[Docket No. FAA-2023-1814; Project Identifier AD-2023-00773-T; Amendment 39-22541; AD 2023-17-14]

Airworthiness Directives; The Boeing Company Airplanes

Final rule; request for comments.

Figure 1 to paragraph (h)(4) – Cap seal minimum thickness (all dimensions in inches)

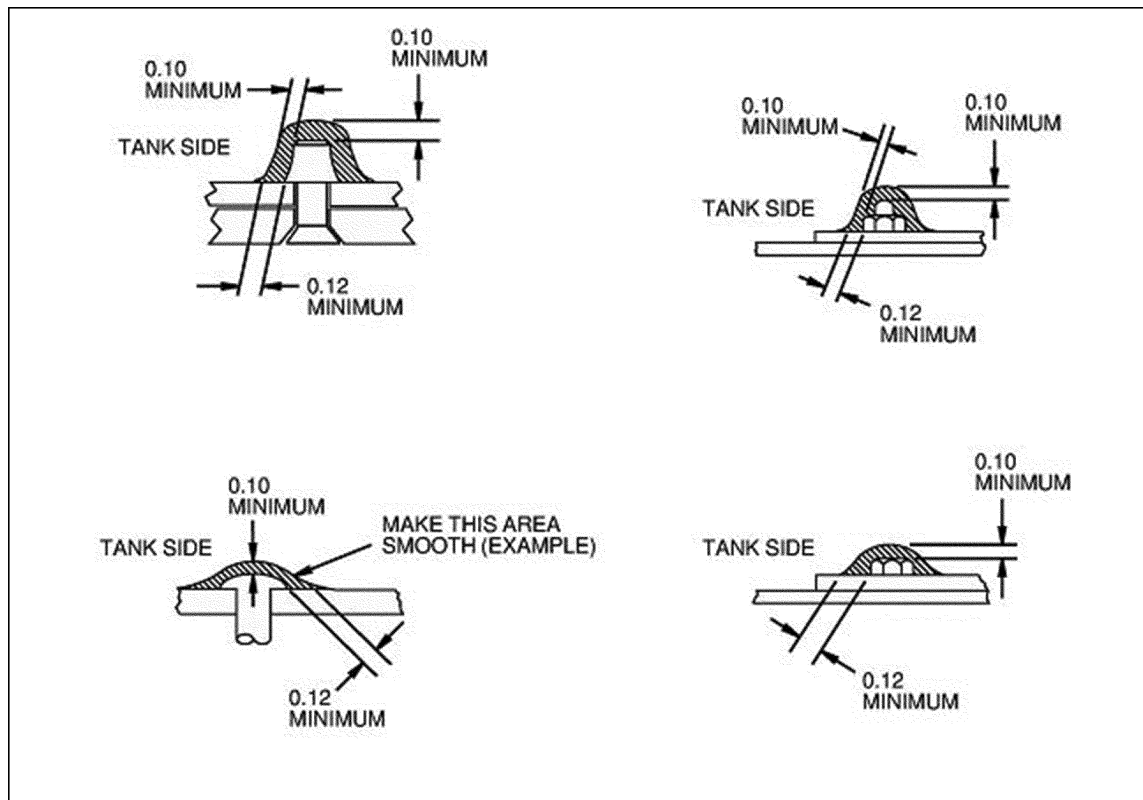
(4) During application of any cap seal to a fastener, fastener head, and fastener threads and collars, as required by this AD, the cap seal must be applied with a thickness equal to or greater than the dimensions specified in figure 1 to paragraph (h)(4) of this AD.

(6) Where Boeing Alert Requirements Bulletin 777-57A0122 RB, dated October 8, 2021, requires inspections that may require the removal of fastener cap seals, this AD requires that if the cap seal is removed, a cap seal of BMS 5-45 sealant be reapplied with a thickness equal to or greater than the dimensions specified in figure 1 to paragraph (h)(4) of this AD before further flight after completion of the inspection.

(ii) All cap seals were applied using procedures with thickness dimensions greater than or equal to those given in figure 1 to paragraph (h)(4) of this AD.

(iii) All cap seals that were removed to accomplish any inspection in accordance with Boeing Alert Requirements Bulletin 777-57A0122 RB, dated October 8, 2021, were replaced with cap seals of BMS 5-45 sealant of thickness dimensions greater than or equal to those given in figure 1 to paragraph (h)(4) of this AD.

(2) If any cap seal was applied using procedures with thickness dimensions less than those given in figure 1 to paragraph (h)(4) of this AD, or if the maintenance records do not definitively specify the procedures used: At the applicable time specified in paragraph (i)(2)(i) or (ii) of this AD, replace the cap seal in accordance with the Accomplishment Instructions of Boeing Alert Requirements Bulletin 777-57A0122 RB, dated October 8, 2021, using a cap sealing procedure with thickness greater than or equal to the dimensions given in figure 1 to paragraph (h)(4) of this AD.

(3) For any cap seal that was not applied, or for any cap seal that was removed for inspections and not replaced, or if the maintenance records do not definitively specify the procedures used: At the applicable time specified in paragraph (i)(3)(i) or (ii) of this AD, apply a cap seal of BMS 5-45 sealant using an accepted method with thickness greater than or equal to the dimensions given in figure 1 to paragraph (h)(4) of this AD.
